MAY 19 1992

L-92-152

Subject: Response to Request for Additional Information  
Related to Topical Report NTH-TR-01, RETRAN Model  
Qualification - St. Lucie Plant Unit Nos. 1 and 2  
and Turkey Point Plant Unit Nos. 3 and 4 (TAC Nos. 75082,  
75083, 75084 and 75085)

Figure 1. PRESSURIZER PRESSURE

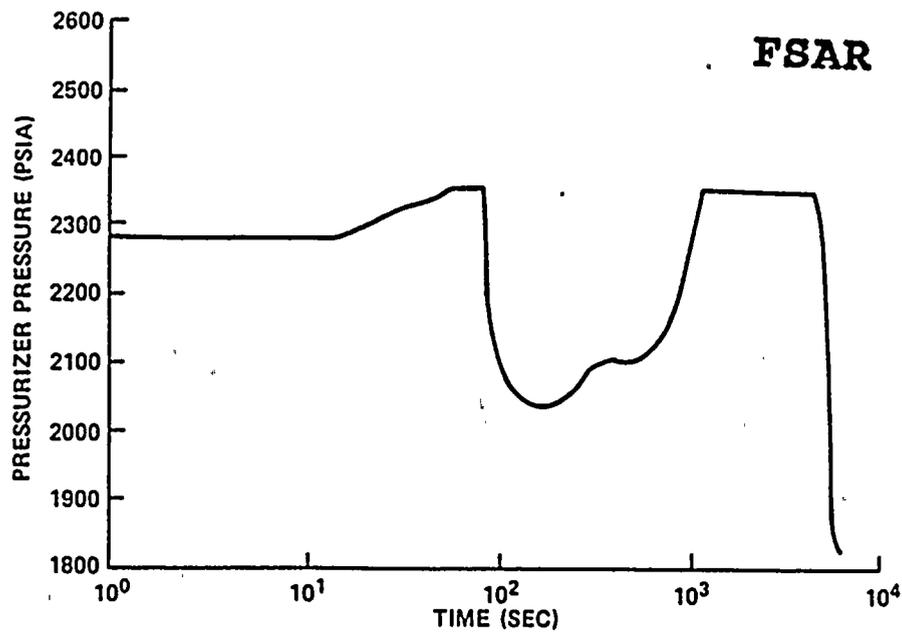
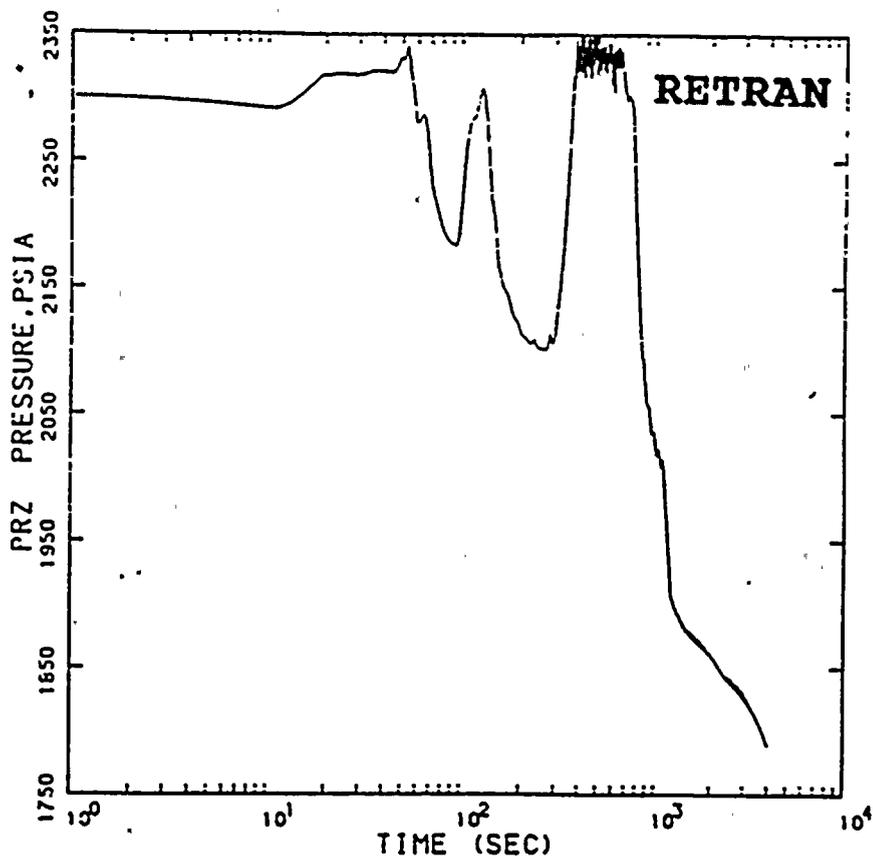
- When choosing assumptions/inputs that are different than those in the corresponding FSAR analysis, provide discussion of impact on results.
- Provide FSAR and RETRAN plots for the Turkey Point Loss of AC Analysis and justify the differences.

Figures 1 through 4 show that there is reasonable agreement between the FSAR and RETRAN results. Differences between the two predictions are attributable to differences between LOFTRAN and RETRAN and in large part are due to differences in the way the heat transfer between the primary and secondary systems is modeled in each analysis. The FSAR calculation uses a Single Node Steam Generator (SNSG) model. To overcome the non-conservatism of the overall instantaneous mixing of the auxiliary feedwater fluid in this type of representation, the heat transfer coefficient is artificially altered in the conservative direction. In the FPL

Differences in the way primary to secondary heat transfer is modeled in each analysis probably explain the different responses to the reactor coolant pumps and turbine trips which happen at about the same time. The resulting cold leg temperature and pressurizer pressure increases are substantially more pronounced in RETRAN than in the FSAR (Figures 1 and 4). Later on, in the RETRAN analysis, the more realistic heat transfer between primary and secondary results in the RCS heatup being turned around shortly after the operator increases the auxiliary feedwater flow from 110 to 230 gpm at 652 seconds.
